**FINAL FINDING OF SUITABILITY TO TRANSFER (FOST) # 4 FOR A
PORTION OF PARCEL 24 (PUBLIC DOCUMENT)**

**FINDING OF SUITABILITY TO TRANSFER
FOR A PORTION OF PARCEL 24
FORMER MARINE CORPS AIR STATION
TUSTIN, CALIFORNIA**

**Response to Comments
Finding of Suitability to Transfer
Marine Corps Air Station Tustin, California**

31 October 2002 Comments on Final FOST from: Ms. Jennifer Rich, Remedial Project Manager, DTSC

Figure 2
Transfer Property Location Map

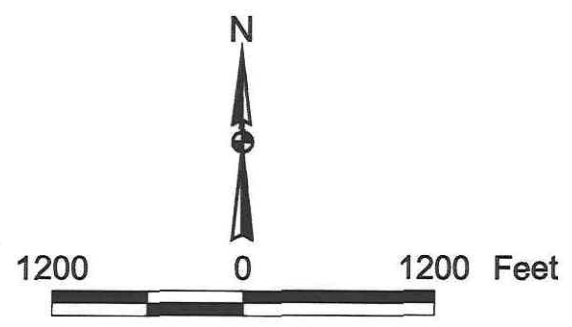
17.	<p><u>Figure 2, Transfer Property Location Map</u></p> <p>In comparing this figure to Figure 2 in FOST #3, there appear to be some differences. Some of the buildings/structures that were shown on the previous figure are no longer shown in this figure for FOST #4, for example, the mooring pad associated with Parcels 23 and 24. Please explain the differences between the two figures and make any necessary changes. There are also areas in the figure that are extremely light in color and difficult to decipher. Please darken those areas.</p>	Any areas in the Transfer Portion of Parcel 24 discussed in this FOST will be darkened, including the mooring pads. FOST 3 figures were completed by a different contractor and therefore have slightly different figures. The differences will be corrected.

Pesticides Work Plan
Figure A1-1
Agricultural Areas at MCAS Tustin

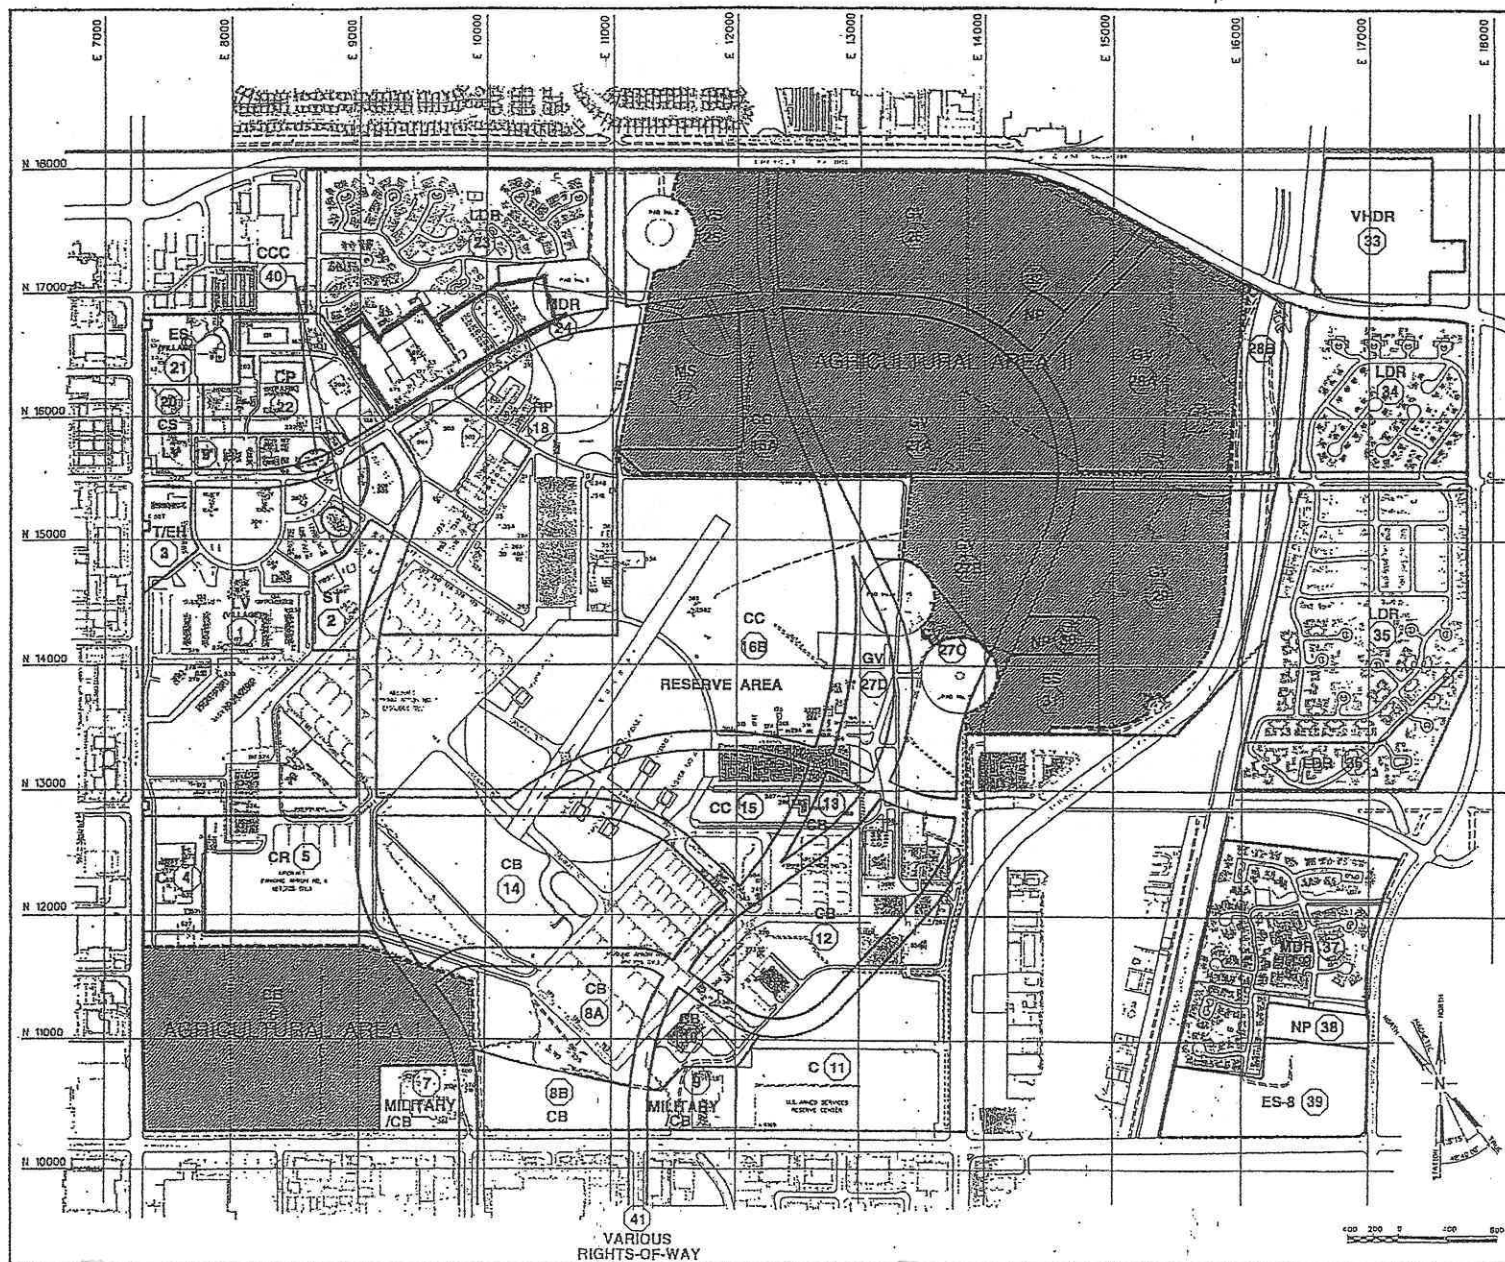
Figure A1-1 from the Pesticides Work Plan shows the areas where pesticides were used on the agricultural areas on the former MCAS Tustin. The figure clearly shows that the transfer portion of Parcel 24 is not in the designated Agricultural area where pesticides were used. The transfer portion of Parcel 24 is outlined to the left of the Agricultural area. No notifications of pesticides is needed for this FOST.
